Subject: MHI's Responses to US-APWR DCD RAI No.794-5871 Revision 0 (SRP 6.5.2)

MHI's Response to US-APWR DCD RAI No. 794-5871 Revision 0

RAI NO.:	**794-5871 REVISION 0**
SRP SECTION:	**06.05.02 – CONTAINMENT SPRAY AS A FISSION PRODUCT CLEANUP SYSTEM**
APPLICATION SECTION:	**DCD Section 6.5.2, 15.6.5 and 15A**
DATE OF RAI ISSUE:	**8/1/2011**

Figure 1. Example of Bypass Leakage Pathway

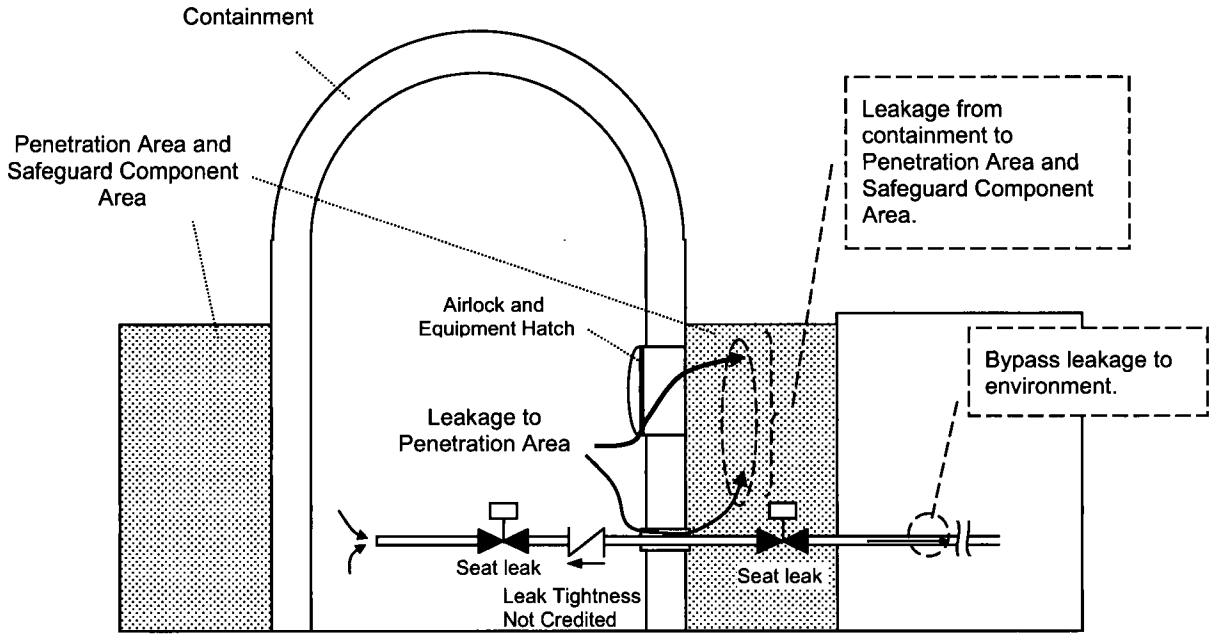
a. Provide the basis and/or rationale for the assumed percentage of direct environmental leakage (bypass of secondary containment and filtration),

The pipes which penetrate containment have isolation valves, and the containment atmosphere during a LOCA is prevented from being released to the environment.

The containment concrete shell inner surface is lined with a minimum 1/4-in. carbon steel plate that is anchored to the concrete shell and dome to provide the required pressure boundary leak tightness. Therefore, it is expected that leakage from containment occurs through piping and other penetration areas, which are enclosed by the Penetration Area and Safeguard Component Area (PASCA). In general, leakage from containment to other areas is expected to be negligible because of high levels of quality assurance in construction and periodic inspections and leakage testing of the containment volume and penetrations.

All containment penetration parts are enclosed by the PASCA. Therefore, all leakage through penetrations enters the PASCA. The Engineered Safety Features Ventilation system maintains the PASCA at negative pressure during design basis accidents, thereby preventing the leakage from traveling to other areas.

Leakage released to the environment in the US-APWR design was calculated assuming all leakage to the PASCA is released to the environment until these areas attain negative pressure, which occurs in about 4 minutes. Bypass leakage (bypassing the PASCA and passing through to the environment) was

calculated for the installed piping penetration parts without crediting the airtightness of piping penetration components. Bypass leakage was assumed from isolation valves on these pipes and calculated using specified design-basis limits for the US-APWR design. Based on BRANCH TECHNICAL POSITION 6-3 Rev.3 (Ref. 1), leakage from piping penetrations which consist of closed systems was excluded from the bypass leakage calculation.

Calculated bypass leak rate corresponds to about [ ] of total containment leak rate. And, this is sufficiently less than [ ] of total containment leak rate [1].

From discussion above, direct bypass leakage from containment to the environment is assumed to be [ ] of containment leak rate in the realistic dose analysis.

Figure 2. Conversion to Realistic Dose Analysis Input of Iodine Re-evolution

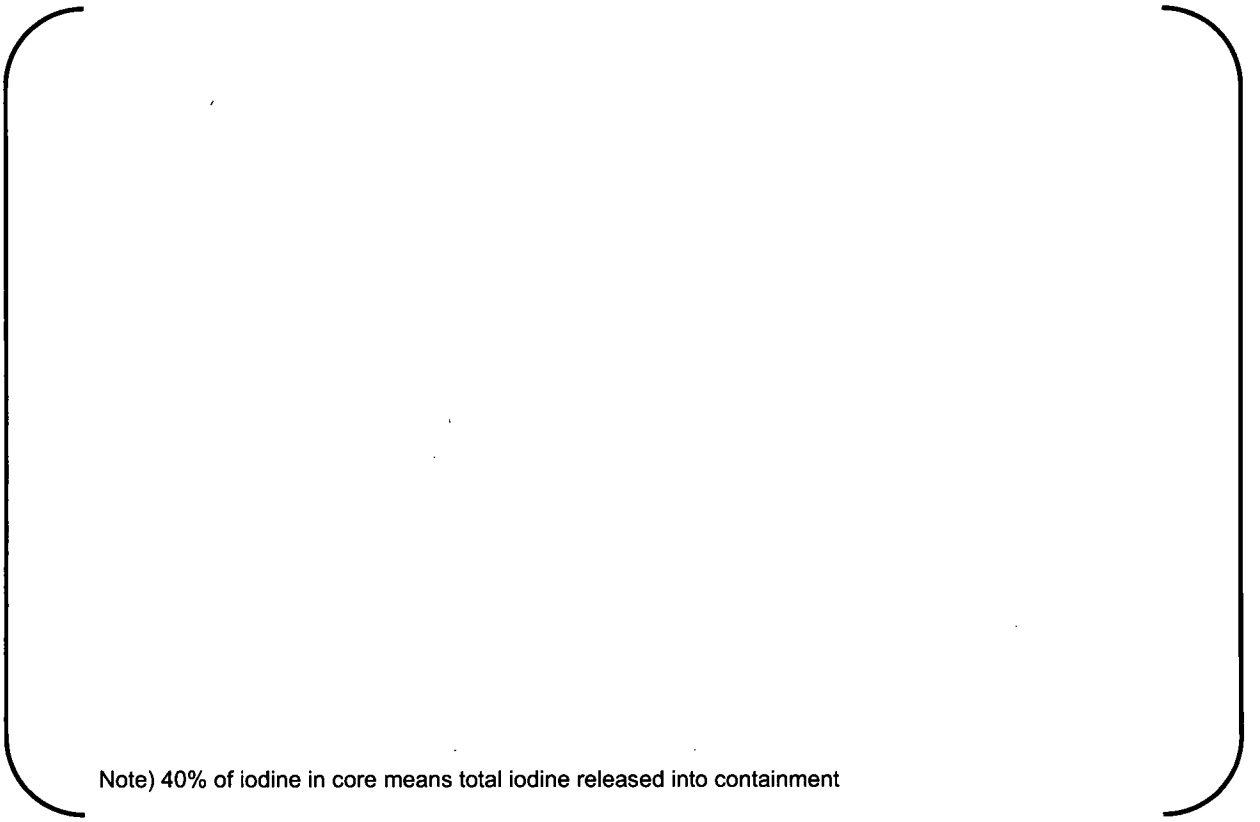
a. How was the graph of iodine re-evolution as fraction of iodine in the recirculation water given in RAI response Figure 4 converted to input values of iodine released as a fraction of core iodine for use in RADTRAD? Give the basis for assumptions used.

The result of iodine re-evolution was assumed to be a linear function. "Fraction" in Figure 4 in the response to RAI 715-5262, Rev.0, refers to iodine re-evolution fraction versus 40% of iodine in the core, where 40% of iodine in core is the total iodine released into containment. In order to derive the iodine re-evolution fraction for dose analysis input, the linear iodine re-evolution fraction was multiplied by the total released iodine fraction into containment. The resulting values are shown in Table 3 in the response to RAI 715-5262, Rev.0.

The re-evolution fraction increases [

Linear iodine re-evolution fraction and conversion to realistic dose analysis input are shown in Figure 2 below.
